## THE INDUS WATERS TREATY 1960

### BAGLIHAR Hydroelectric Plant

### Expert Determination

on points of difference referred by the Government  
of Pakistan under the provisions of the Indus Waters Treaty

Figure 5.2.1: Upstream elevation of the dam, India's design

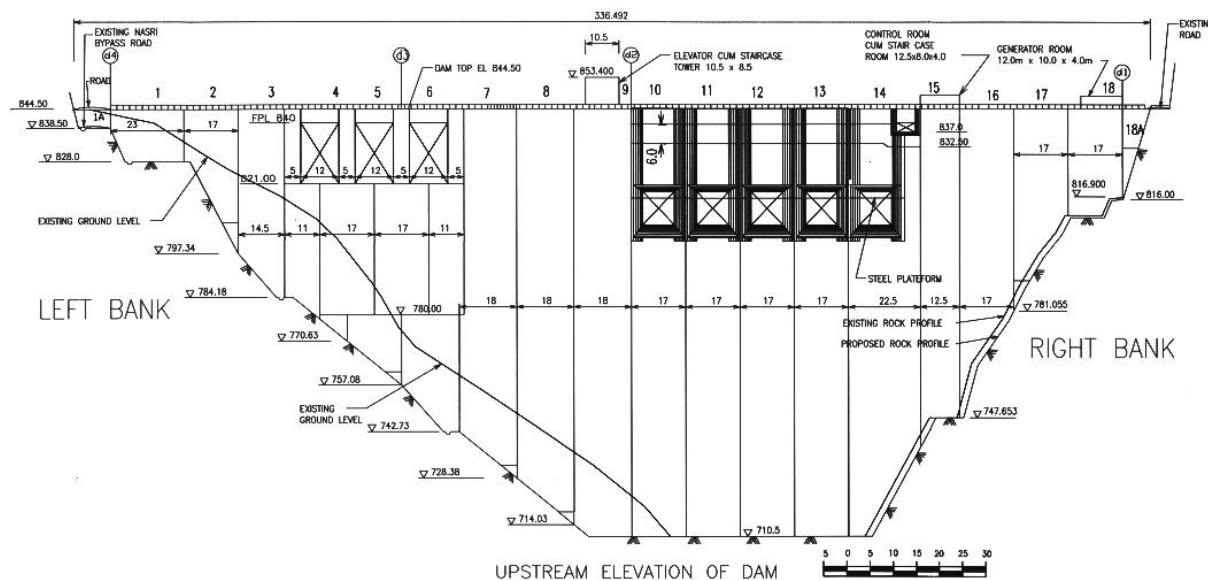
The configuration of the design submitted by India during Meeting No. 1 is a combination of five bays on the sluice spillway located in the river axis, three bays on the chute spillway on the left part of the dam and one auxiliary spillway on the right bank. Copies of the corresponding drawing are provided in Annex 4.1 (pages 3 to 7). Figure 5.2.1 shows on an upstream elevation the layout of the devices as proposed by India.<sup>22</sup>

The spillway outlets have been designed to allow for the release of the Probable Maximum Flood (PMF), which has a peak discharge of 16,500 m<sup>3</sup>/s.

Figure 5.2.2: Upstream elevation of dam, Option A-2 proposed by Pakistan

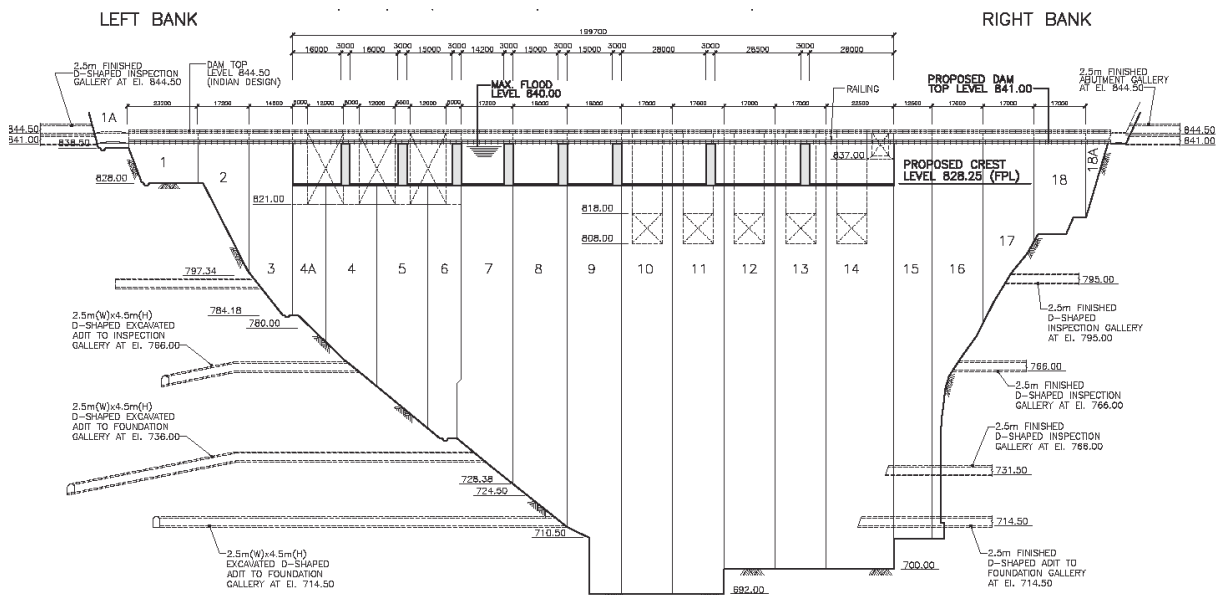
order to maintain the power production at the same level as in India's alternative, the NE will take Option A-2 for the comparison.

Drawings describing this option are provided in Annex 5.2.1.

Figure 5.6.1: Sedimentation of the Baglihar reservoir

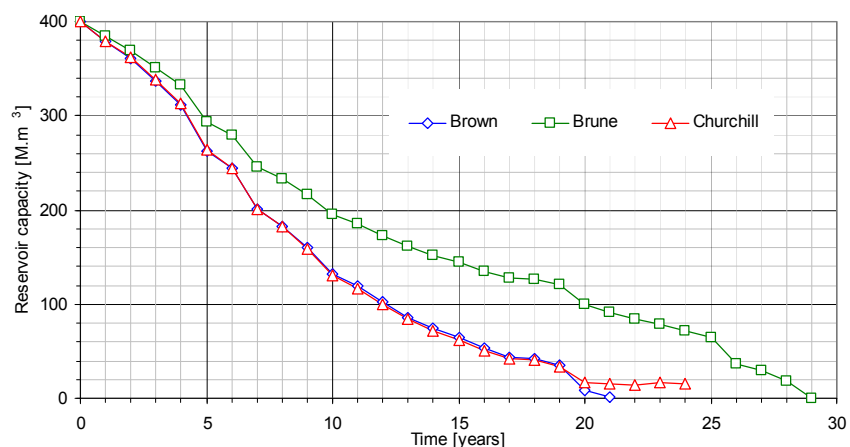
Figure 5.6.1 shows the evolution over time of the loss of dead storage capacity and Figure 5.6.2 indicates the reduction of the sediment trap efficiency as the reservoir dead storage fills up.

The infilling time lies between 20 and 30 years. It can be seen that Brown and Churchill relationships give similar results (this statement can also be found in literature).

Figure 5.10.1: Power intake - longitudinal section.

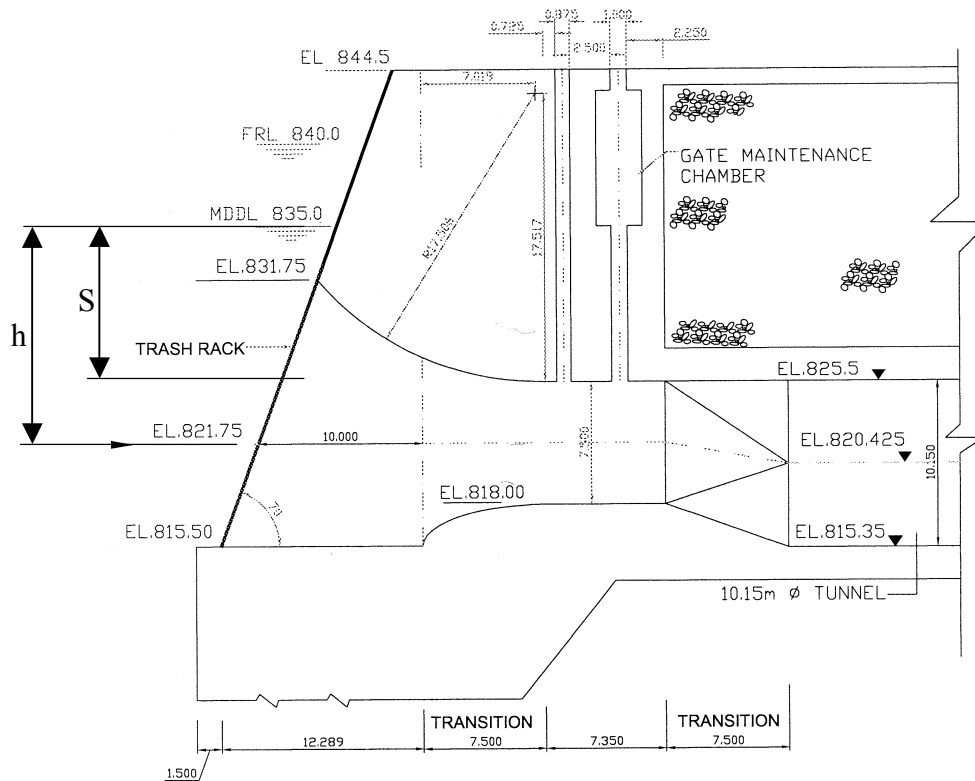
The shape of the upper surface of the intake structure, as shown in Figure 5.10.1, has been modified compared with the Figures provided in pages 8 and 9 to Annex 4.1, (which are extracts from India’s Counter-Memorial) to avoid a corner shape on the vertical profile.

It should also be pointed out that in Figure 5.10.1 the gate sill elevation – rectangular - is fixed at el. 808.0, while the tunnel bottom elevation – circular - is at a lower elevation.

Figure 5.10.2: Simplified geometry of intake.

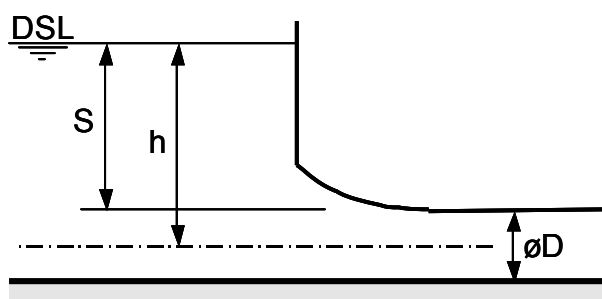
Gordon considered the simplified case of a circular section outflow conduit placed on a flat pond bed, as shown in Figure 5.10.2. These conditions are certainly not representative of a real project, but they give a good indication of the required submergence depth.

The NE examined the situation and found that the calculation of submergence depth with the section of the tunnel (circular, 10.15 m diameter) is not relevant. The formulae consider a simplified geometry for the vortex formation, as shown in Figure 5.10.2. In such geometry, the section available for a possible rotational movement increases from the conduit section to the pond surface. This is not the case when starting in a tunnel section, as upstream of the tunnel section, the channel is divided into two gate conduits. A swirl may be imagined in each conduit, creating each a specific rotational momentum. It is hardly possible for these two movements to join into a common rotational movement in the tunnel section. The friction between the two flows rotating in the same direction will annihilate the rotational movement. The central pier prevents the development of a vortex downwards to the tunnel section.
